Transmitted herewith in accordance with the requirements of 10CFR50.59 and 50.90, is an application for amendment for DPR-49 (Appendix A to License) for the Duane Arnold Energy Center.

PROPOSED CHANGE RTS-76 TO DAEC TECHNICAL SPECIFICATIONS

GENERAL ELECTRIC BOILING WATER REACTOR
RELOAD NO. 1 LICENSING SUBMITTAL
FOR

DUANE ARNOLD ENERGY CENTER

Figure 6-6. Control Rod Drive and Scram Curves at End of Cycle.

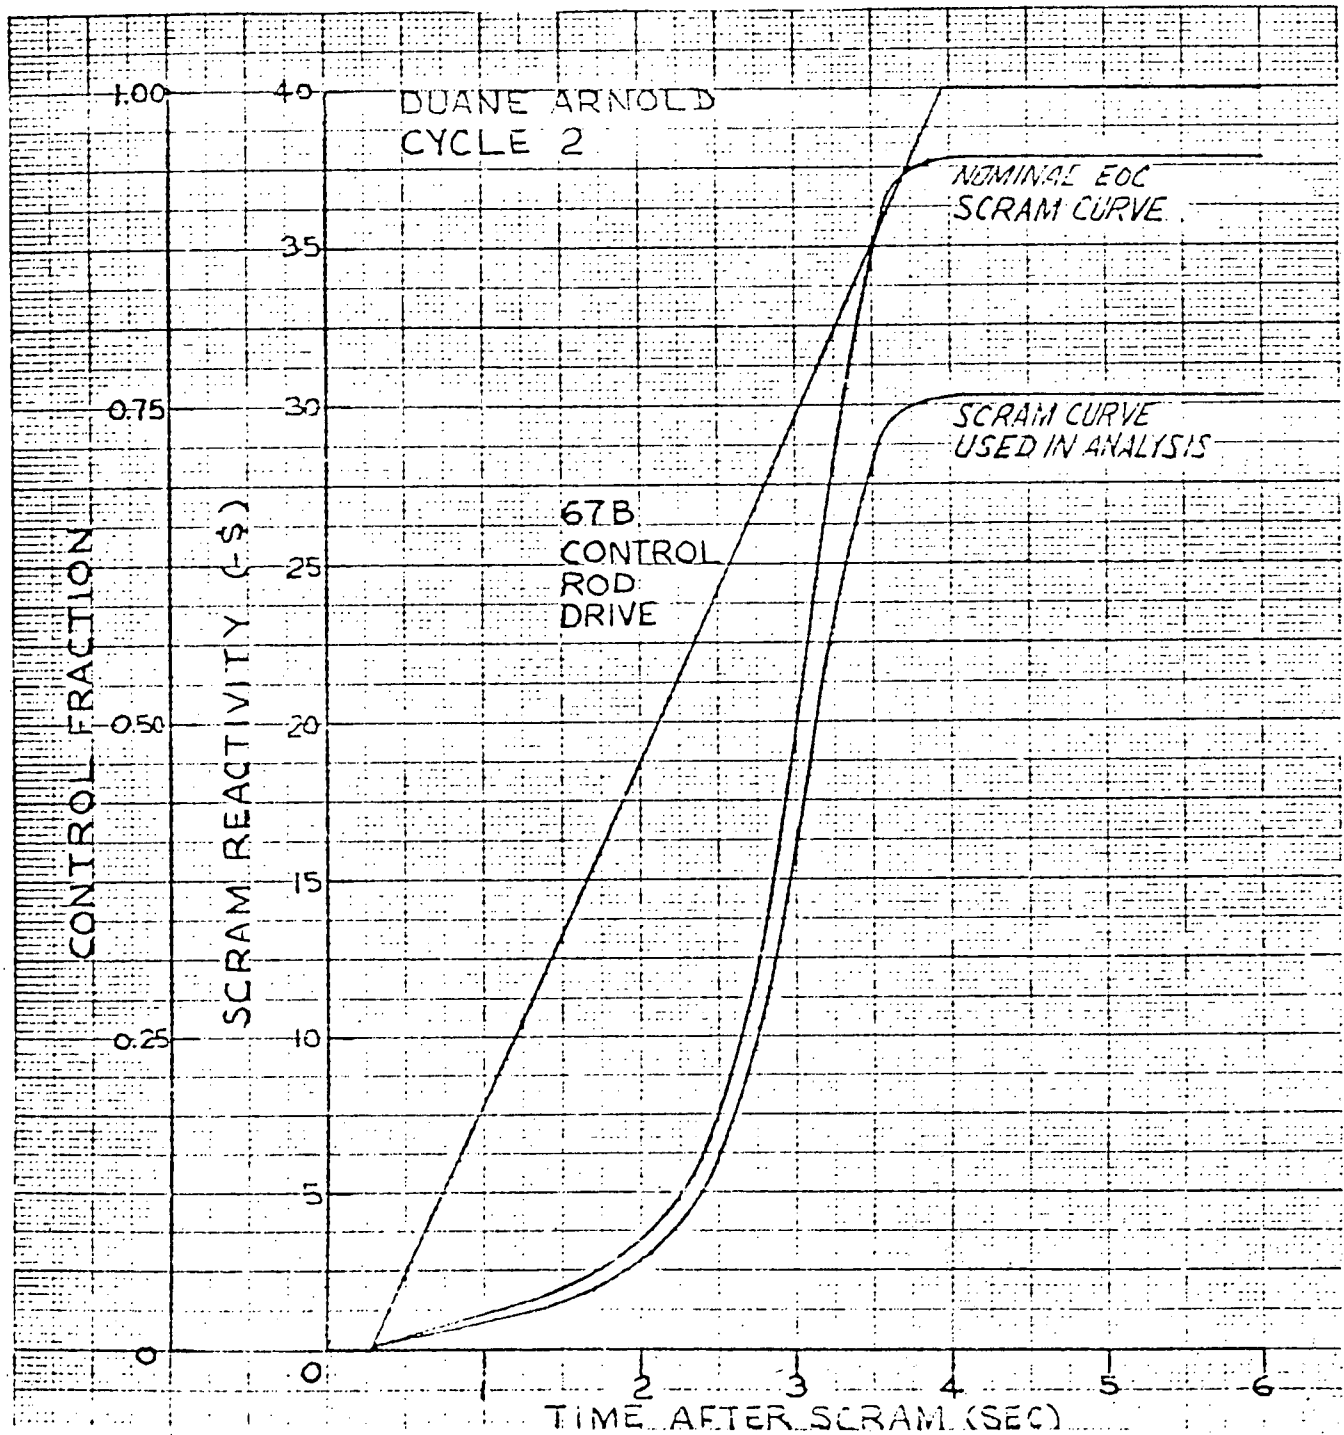
Supplement 2 provides transient analysis for cycle 2 incremental exposure beyond 2600 MWD/T, using an increased bypass flow rate for a plugged core. Full scale tests⁴ have demonstrated that the total bypass flow for the plugged configuration is greater than was used in the previous analysis. The use of the new bypass flow data results in less bypass voiding, which in turn results in a change to the EOC scram curve and a less negative void coefficient.

Figure 6.7c Turbine Trip Without Bypass- Increased Core Bypass Flow

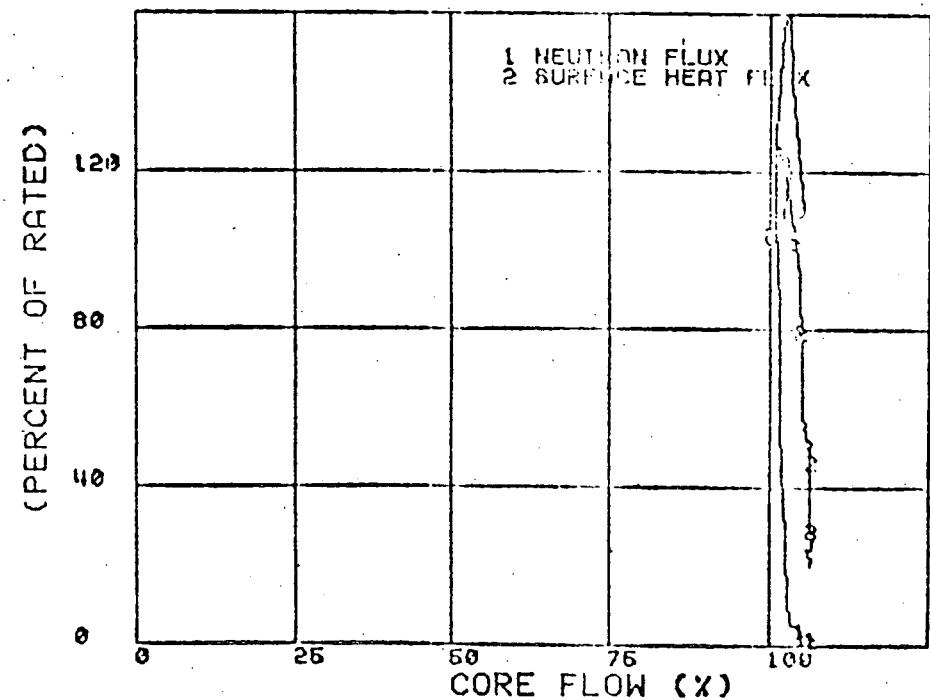
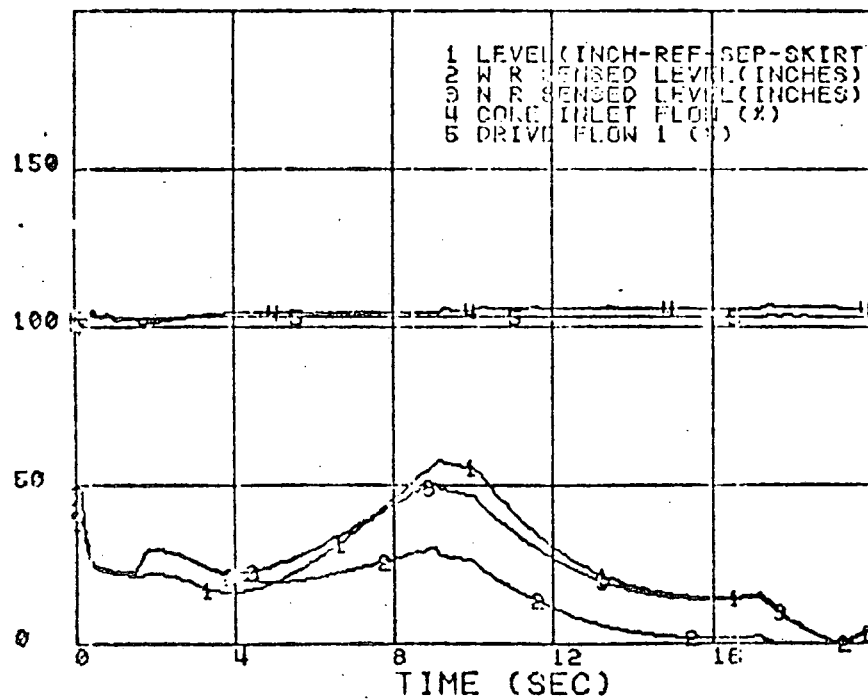
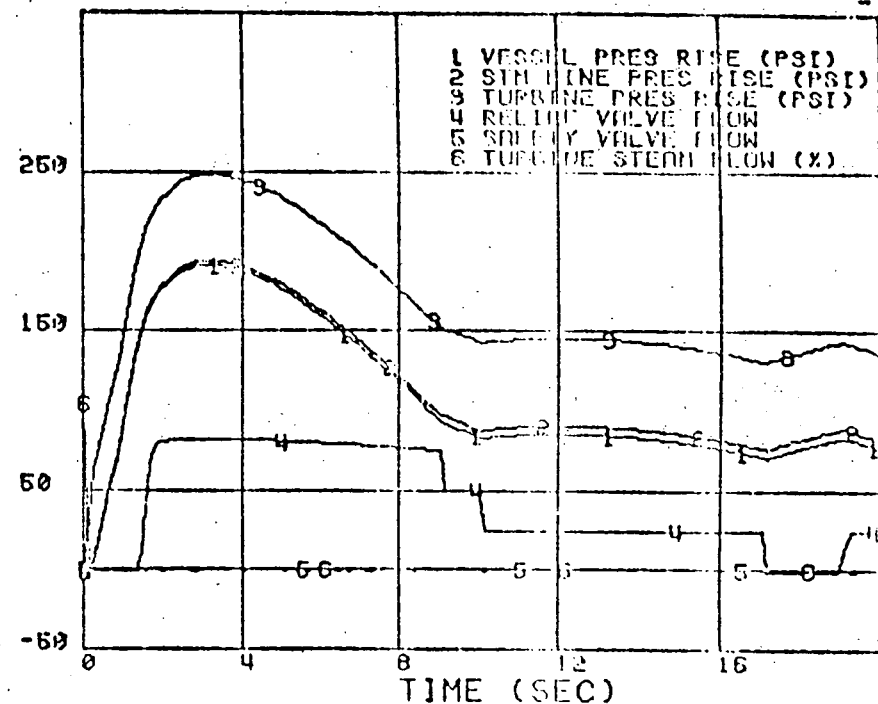
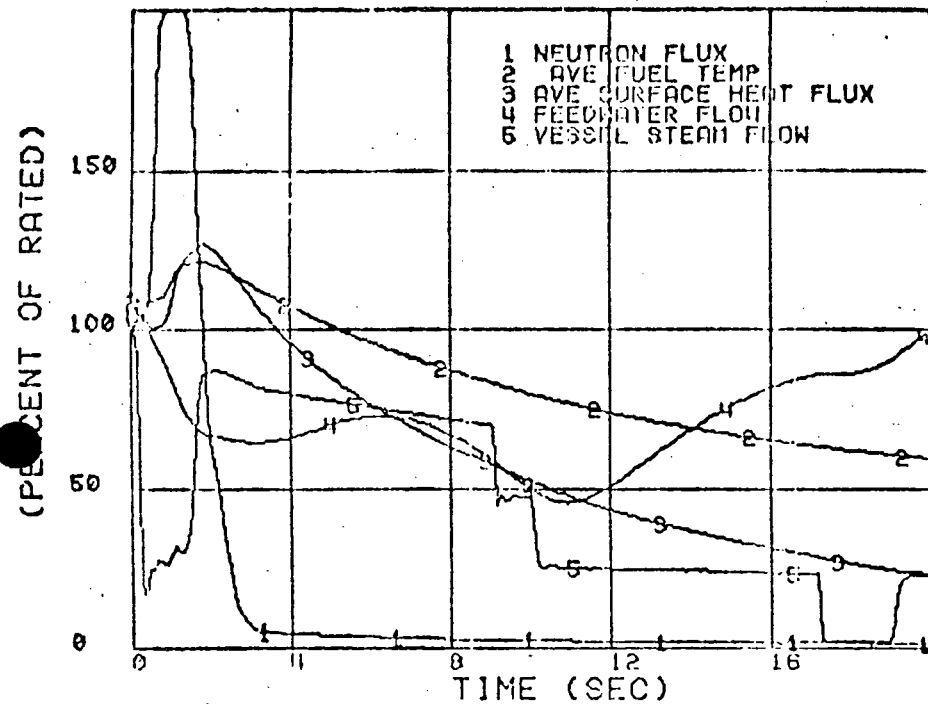
6.3.3.2.1.1 Turbine Trip With Failure of Bypass Valves for cycle 2 incremental Exposure Beyond 2600 MWD/T, Using Increased Core Bypass Flow.

The time responses of the key variables are shown in Figure 6.7c.

The turbine trip without bypass transient proves to be the limiting transient with respect to the pressure margin of the peak steamline pressure to the lowest setpoint of the spring safety valves (1240 psig). The 31 psi margin for cycle 2 exposures beyond 2600 MWD/T provides surplus margin beyond the 25 psi required margin.

Figure 6.8a. Loss of 100°F Feedwater Heater, Increased Bypass Flow

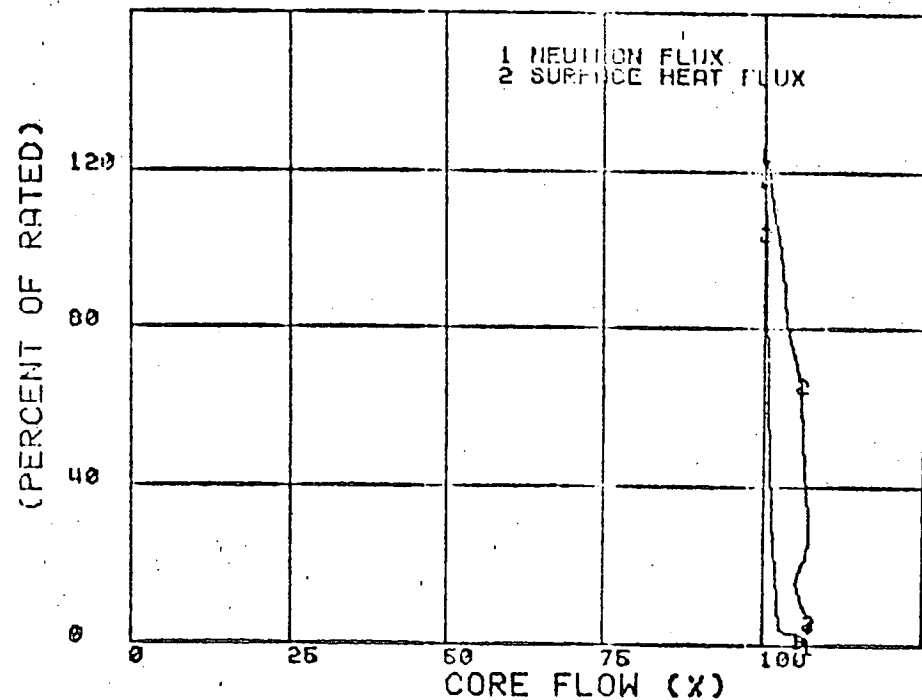
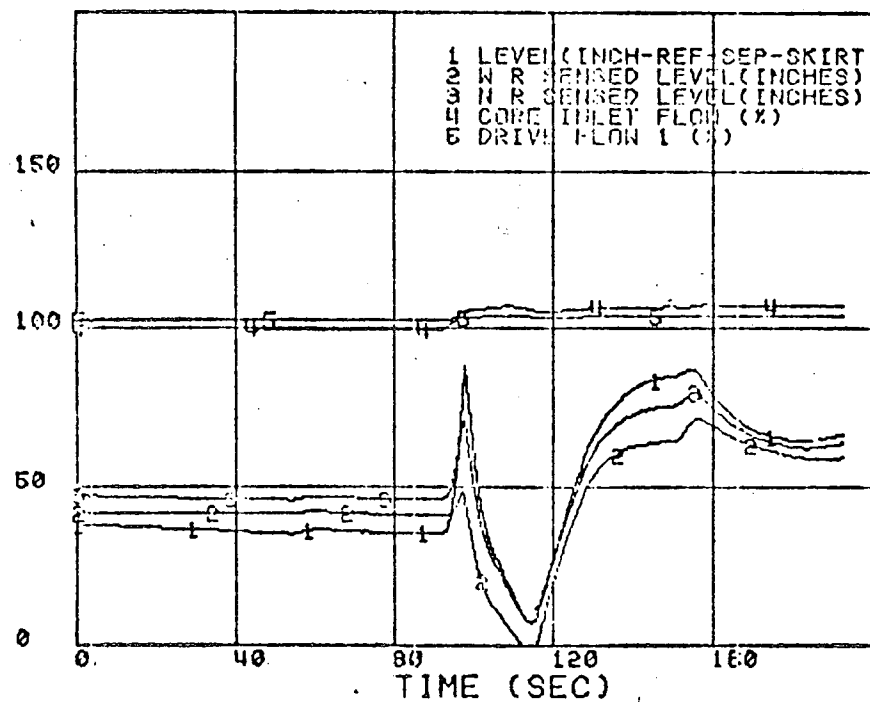
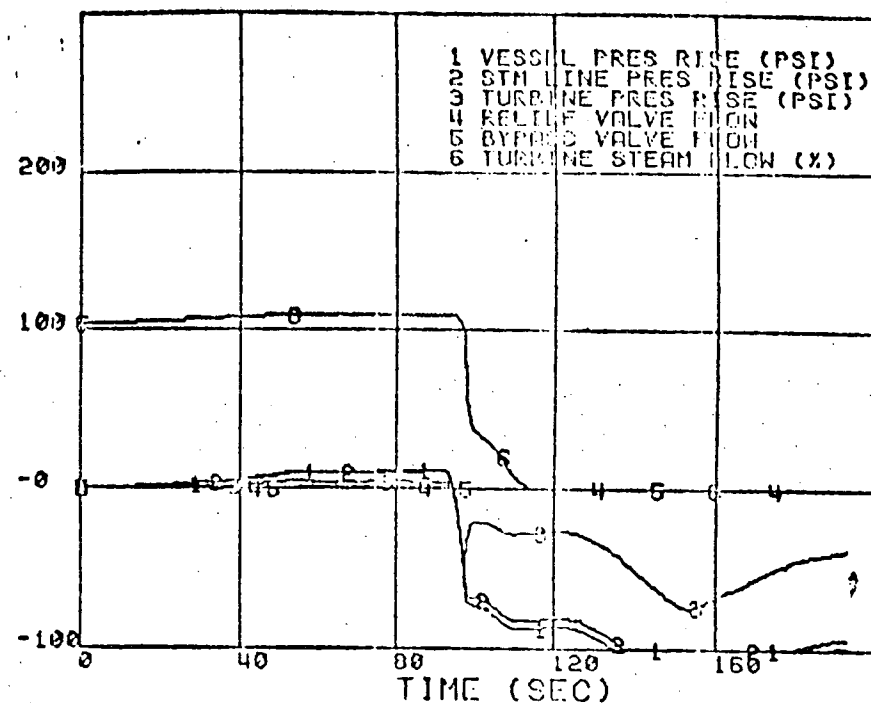
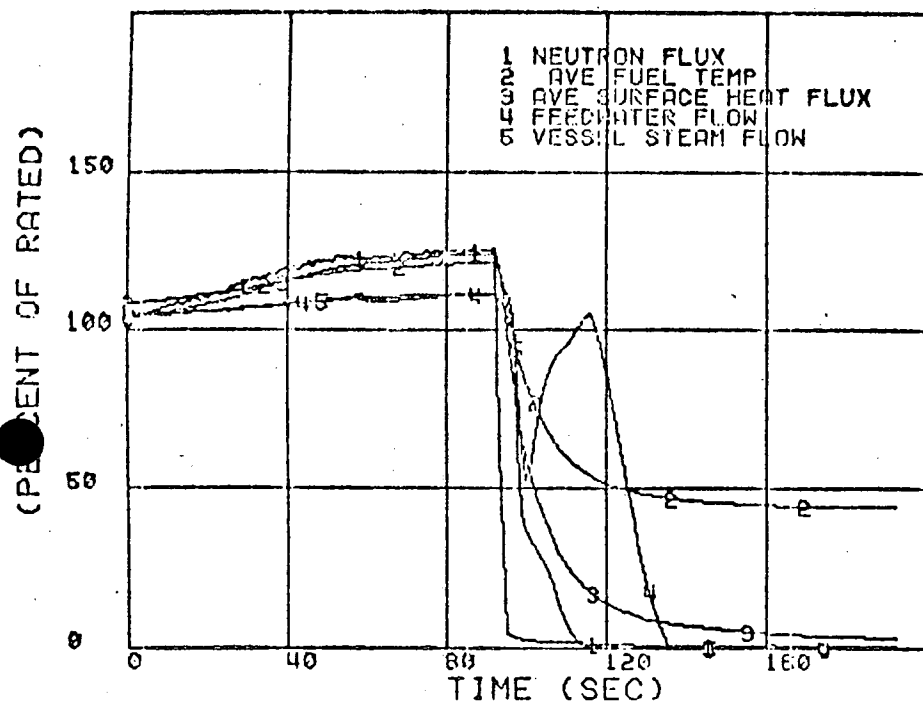
6.3.3.2.2.1 Loss of a Feedwater Heater for cycle 2 Incremental Exposure Beyond 2600 MWD/T, Using Increased Core Bypass Flow.

The time response of this transient is illustrated in Figure 6.8c;
